SERVICE BULLETIN

Title: Guide Vane Crank Arm

Models Affected: 19DK, 19DM, 19EB4, 17/19FA4, 19HR

Number: C9109

PART NO. 19DM212-1322
GUIDE VANE CRANK ARM

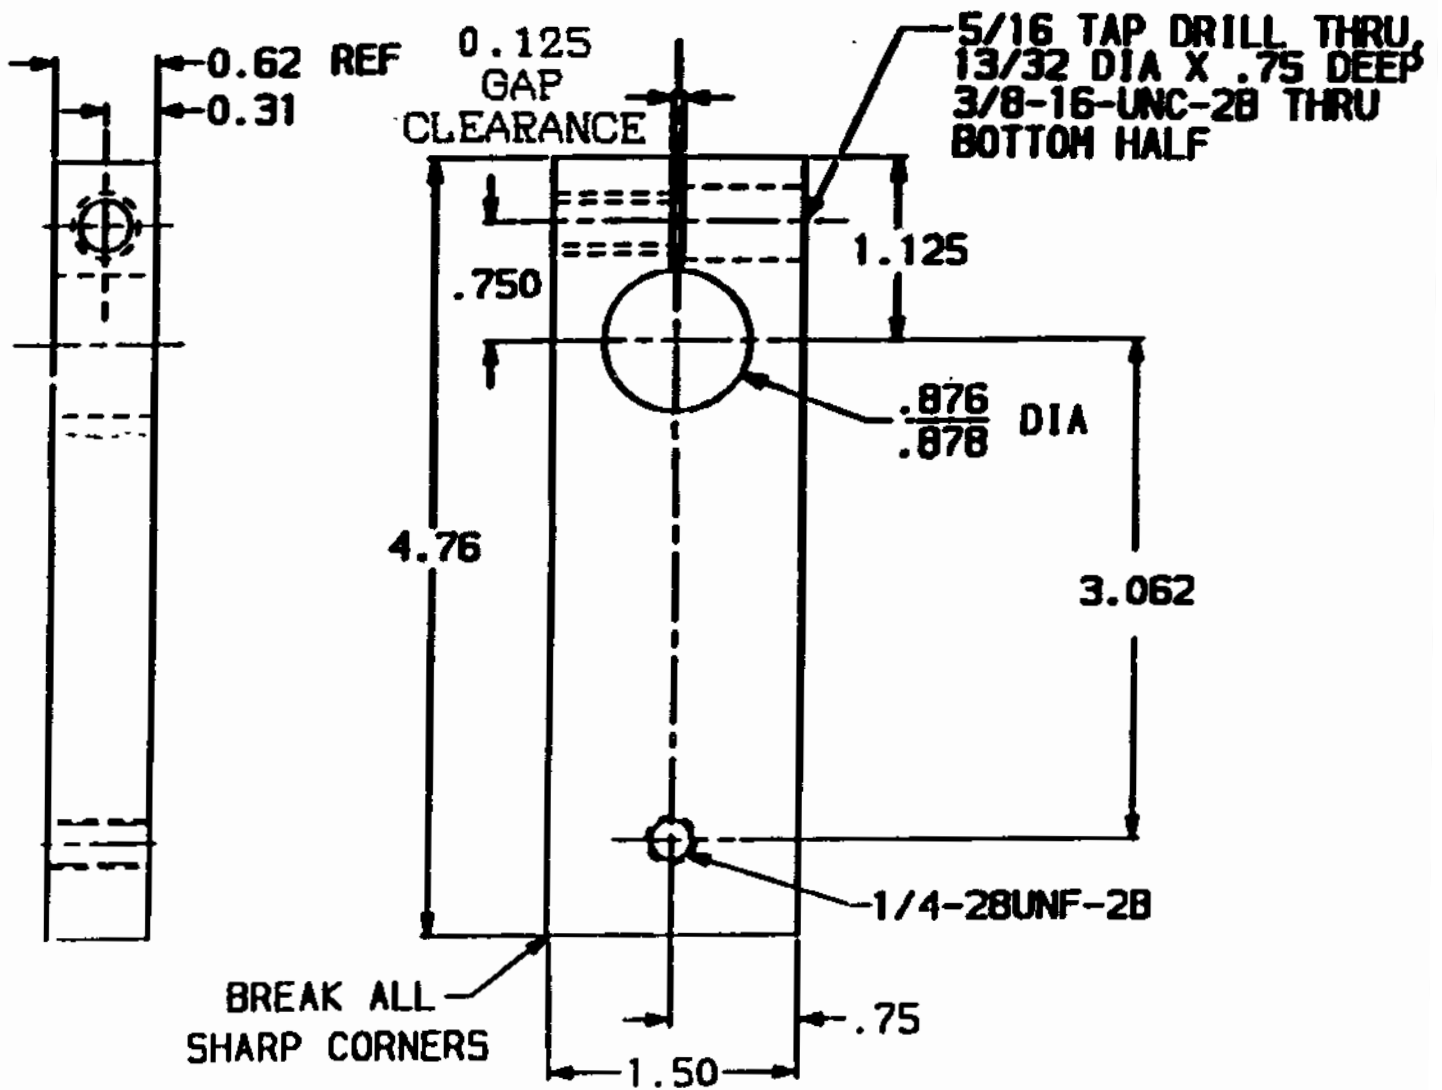
During March 1988, the guide vane crank arm and drive shaft underwent design changes in an effort to eliminate slippage problems. In some instances, however, slippage problems are still being reported. In order to completely eliminate this problem, the new crank arm is going through a slight modification during production. This modification increases the gap clearance from 0.062" to 0.125" allowing the crank to exert more clamping pressure around the drive shaft when the hex screw is tightened. The part no., 19DM212-1322, has not changed.

If a new guide vane crank arm slips, machine the gap clearance to 0.125. This gap clearance is illustrated in the accompanying drawing.
